HOLGATE APARTMENTS

DESIGN REVIEW BOARD RECOMENDATION

PROJECT # 3011576

JULY 24, 2012

ALLEY DESIGN

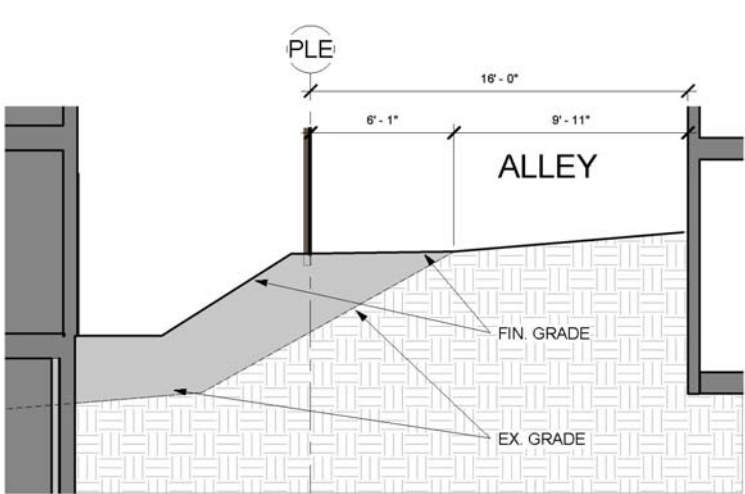
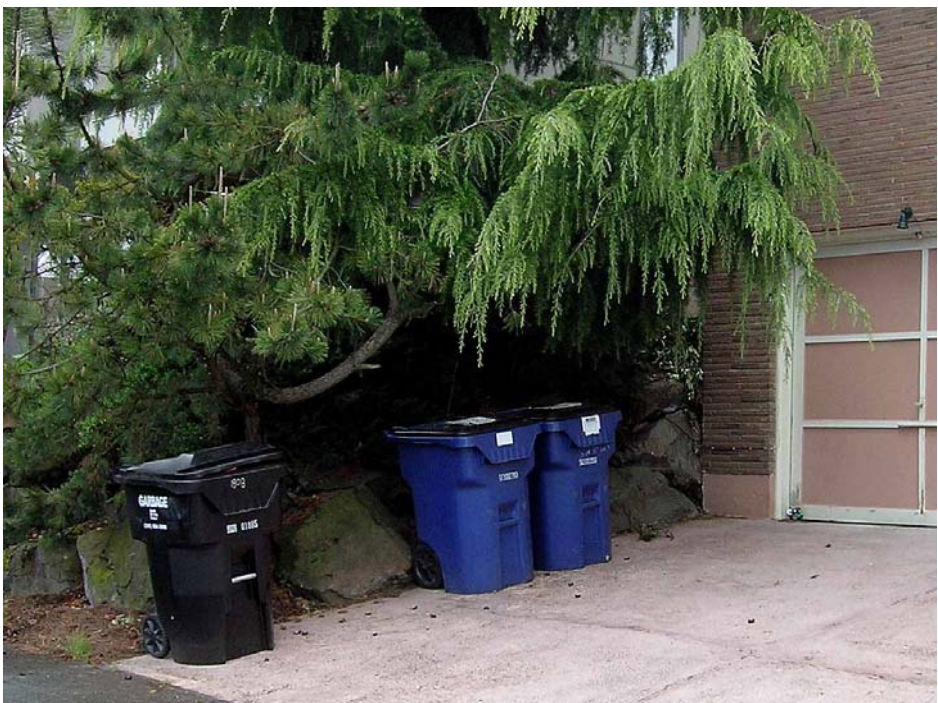
The Board requested that the applicant study placing the solid waste and recycling area near the alley. This will entail discussions with SDOT and Seattle Public Utilities. (March 13, 2012)

The Board expressed its satisfaction with locating vehicular access on 12th Ave. S. Potential placement of solid waste storage on the alley interested the Board. This alternative should be explored and resolved by the Recommendation meeting.

The Board had incorrect information about the pattern for solid waste pick up in the neighborhood and about the requirements to improve the alley and did not consider some of the issues that were discussed during the first EDG meeting.

During the Board's discussion about the proposed location of the solid waste on the West façade of the garage at the 1st EDG meeting they considered the alley location but decided that due to the impacts on the neighbors it was more desirable to have the solid waste in the garage.

The incorrect information regarding the pattern of solid waste pick up in the neighborhood was that all of the solid waste for the apartment buildings on the block that have access to the alley between 12th Ave S. and 13th Ave. S. was picked up in the alley. This is not correct. Most of the apartment buildings solid waste is picked up in either 13th Ave S. or in 12th Ave S. There is minimal if any solid waste pick up in the alley for the building across the alley from the project. The only building on the block that has alley pick up for all of their solid waste is the townhouse project on the corner of 12th Ave S. and S. Graham St..

The incorrect information about the requirements for alley improvements was that SDOT would require that the project improve the alley by paving it. This is also not correct only DPD can require alley improvements based on whether the project uses the alley for either access for parking or for access to solid waste. The City of Seattle has determined that no alley improvements are required for the project.

The applicant believes the currently proposed location of solid waste in the garage is less disruptive to the neighbors and more convenient and safer for the residents, especially disabled residents, of the project than a likely exterior location that abuts the alley. Furthermore the location of the proposed pick up location in 12th Ave S. has significantly less impact on the neighbors across 12th Ave S. because it is approximately 56 feet away from their houses as compared to a pick up location in the alley that would be only several feet away from the apartments to the east.

LANDSCAPE DEPARTURE

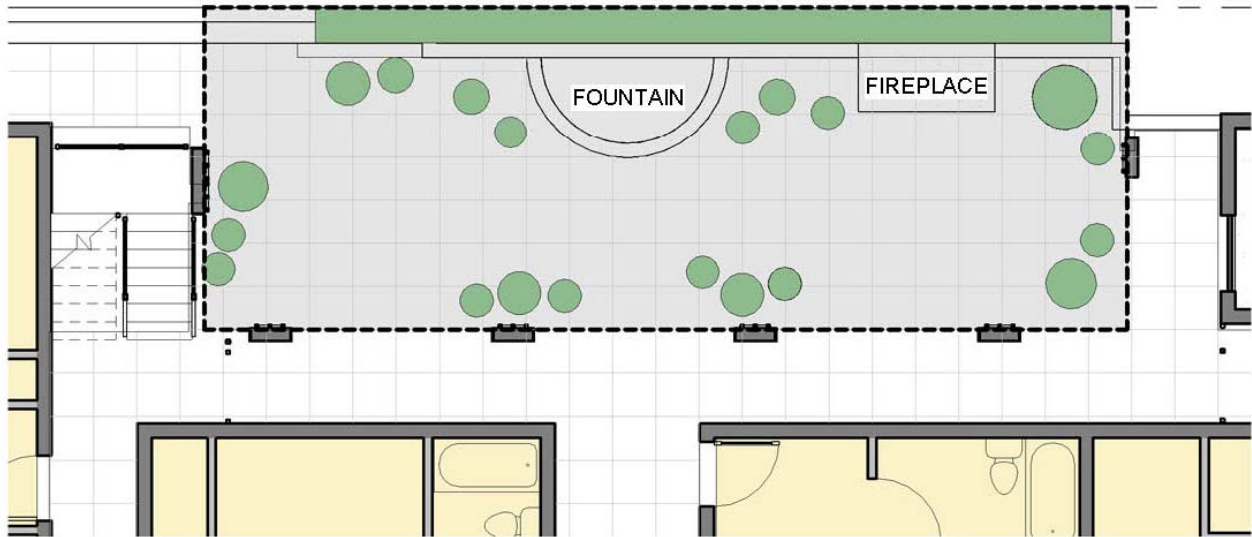
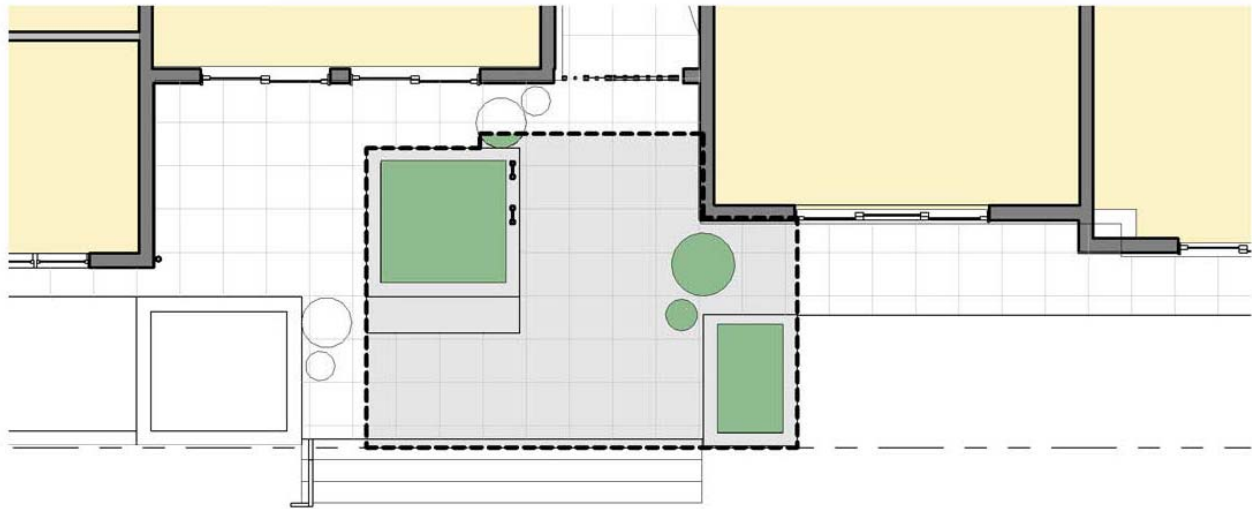
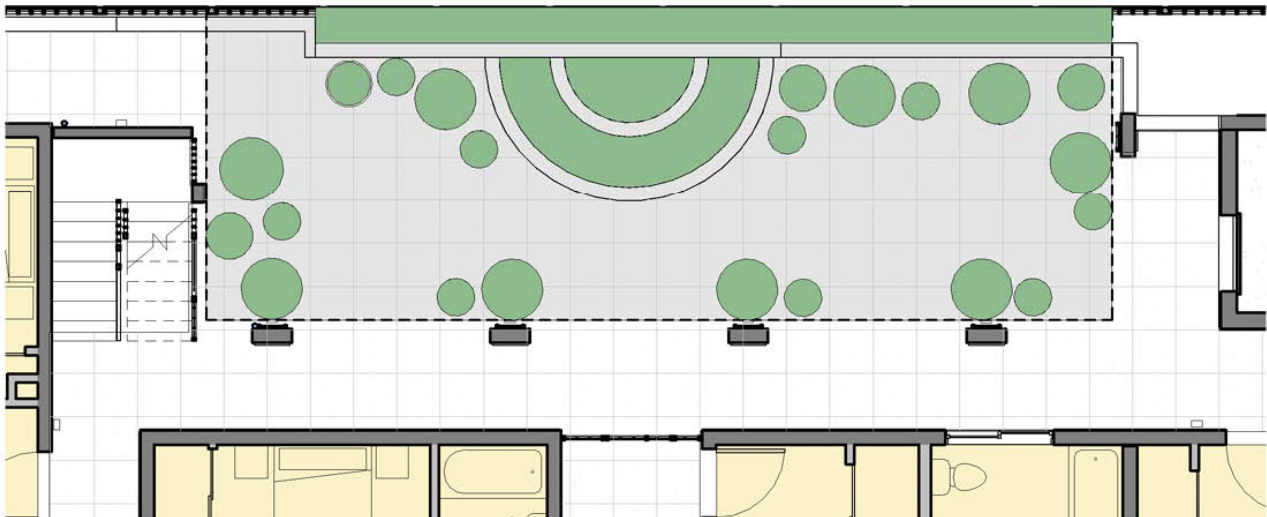
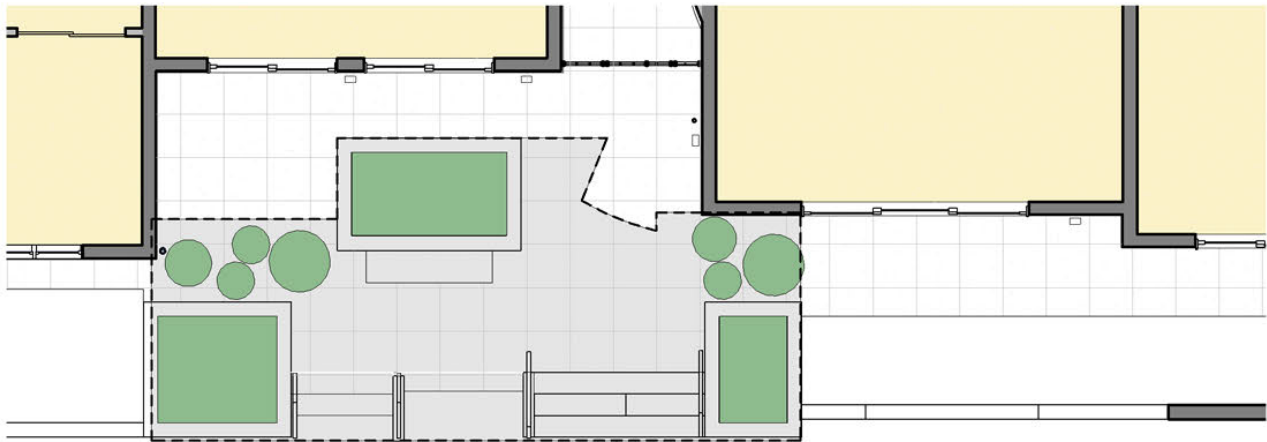
The rear patio should have more plantings than enumerated by the applicant's departure request. The fencing/screening that occurs along 12th Ave. S. should be carried around to the north property line.

4. Landscape. The zoning code requires landscaping 50% of the amenity area in the entry and rear courtyards. The applicant requested landscaping totaling 10 to 15%. The Board stated that this figure was too low.

The landscape plan has been changed to provide 28% of the entry courtyard and 32% of the rear patio courtyard in landscaping.

The landscape plan has been changed to provide 28% of the entry courtyard and 32% of the rear patio courtyard in landscaping.

FENCE AT NORTH PROPERTY LINE

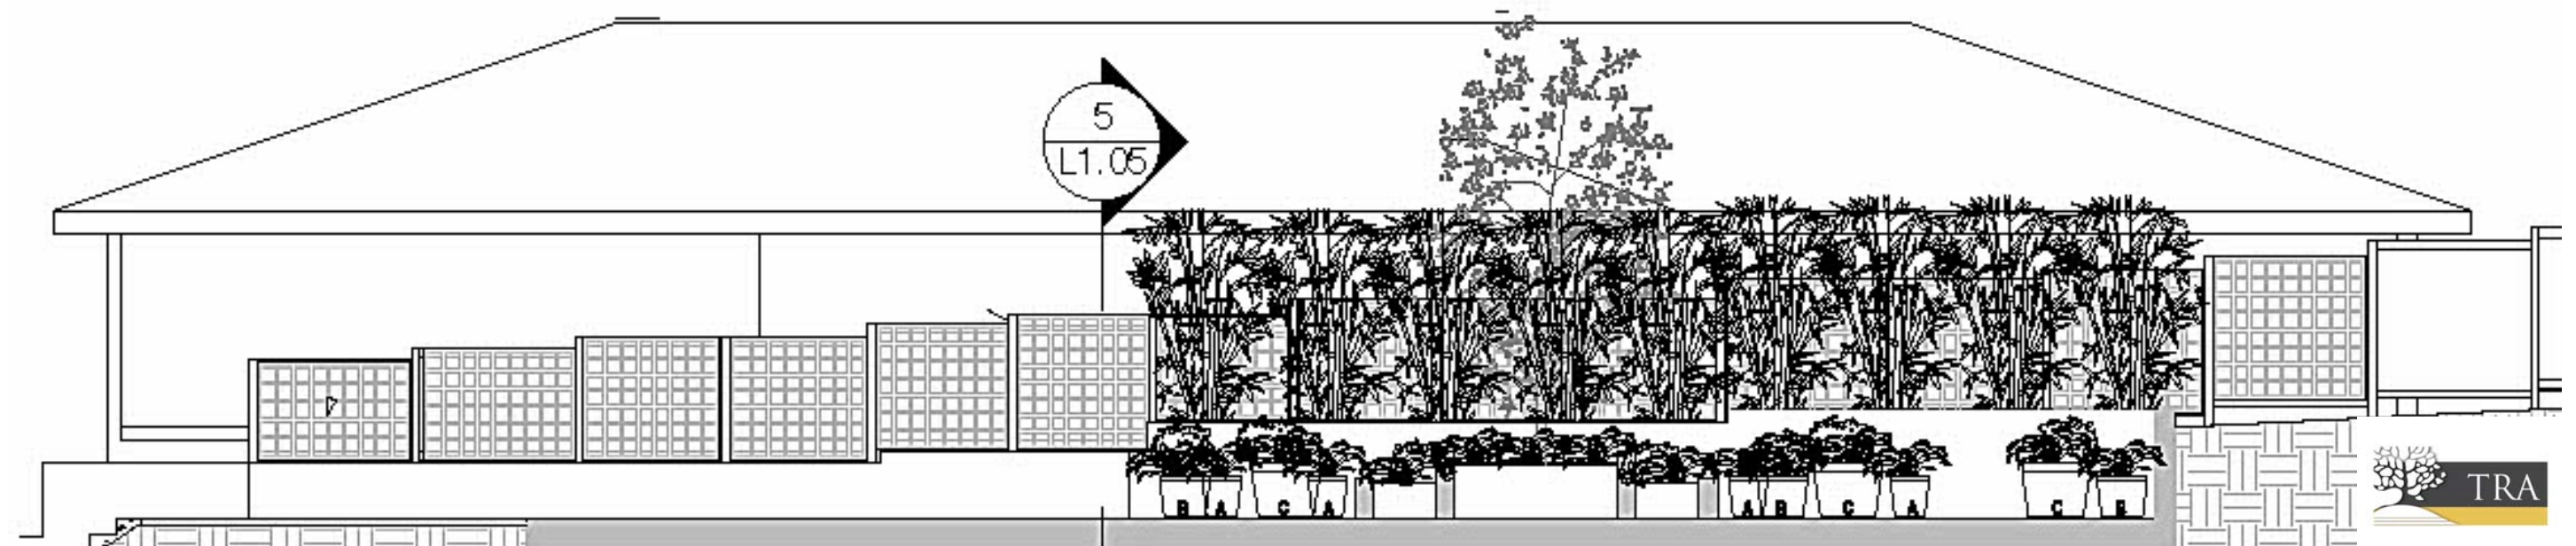
The north side of the project, including the patio area, received considerable discussion. The relationship of the building and court with the adjacent apartment building concerned the Board. A sectional study should reveal the relationship of the two properties by highlighting the applicant's attention to privacy (lighting, screening). The Board noted its keen interest in the materials and detailing of the balconies and balustrades. An elevation, as well, of the exterior hallway overlooking the courtyard is required for the Recommendation meeting. This should also be included in the MUP plan set. (March 13, 2012)

The applicant proposes a solid 6' high wood fence to screen the two properties and provide some security to the building. The applicant also proposes to add a wood trellis to the inside of the solid wood fence to add texture and a structure for vines to grow up to soften the fence from the project's side. An elevation of the fence is provided to show the extent of the fence and the trellis.

The fence along the north property line is proposed to be a standard wood fence with solid boards on the outside facing the neighboring property with a 2 x 2 lattice on the inside facing the courtyard to match the 2 x 2 lattice fence screening the units facing 12th Ave S. The solid fencing is necessary for both privacy and security.
